ECE/TRANS/WP.29/GRE/2009/22
16 January 2009

Proposal for draft 01 series of amendments to Regulation No. 112
(Headlamps emitting an asymmetrical passing beam)

Submitted by the expert from the Working Party "Brussels 1952" */

Figure A: Spherical Coordinate Measuring System

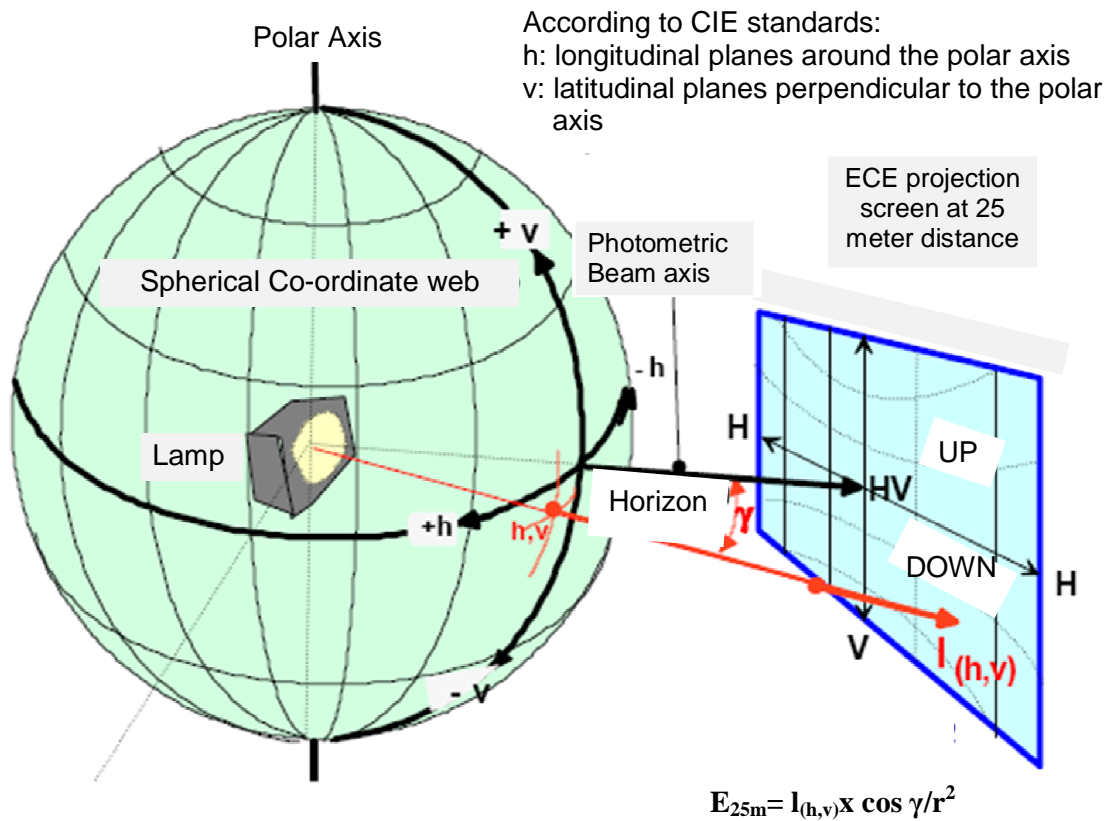
Annex 3, amend to read:

SPHERICAL COORDINATE MEASURING SYSTEM AND TEST POINT LOCATIONS

Figure B: Passing Beam for right-hand traffic

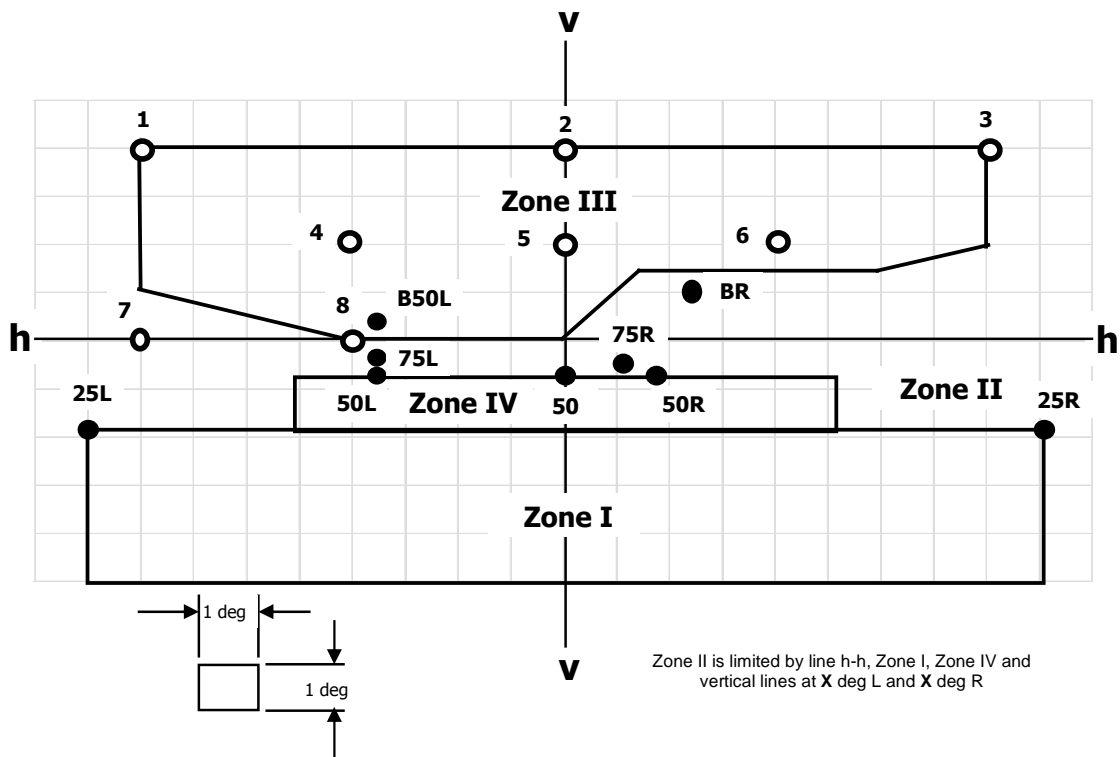
"6.2.4. **The passing beam shall meet the luminous intensities at the test points referred to in the table below and in annex 3 figure B (or mirrored about the VV line for left-hand traffic) shall meet the following requirements:**

The test point locations for left-hand traffic are mirrored about the VV line

Figure C: Driving Beam

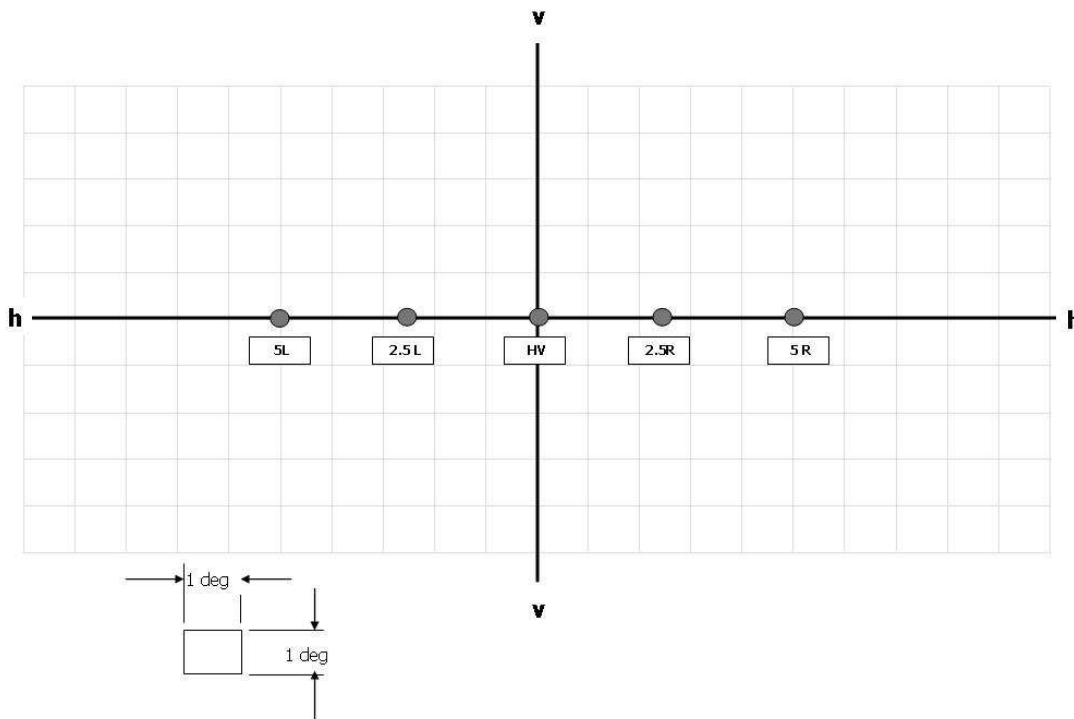
"6.3.3. Referring to Annex 3 Figure C and the table below, the luminous intensity distribution of the driving beam shall meet the following requirements:
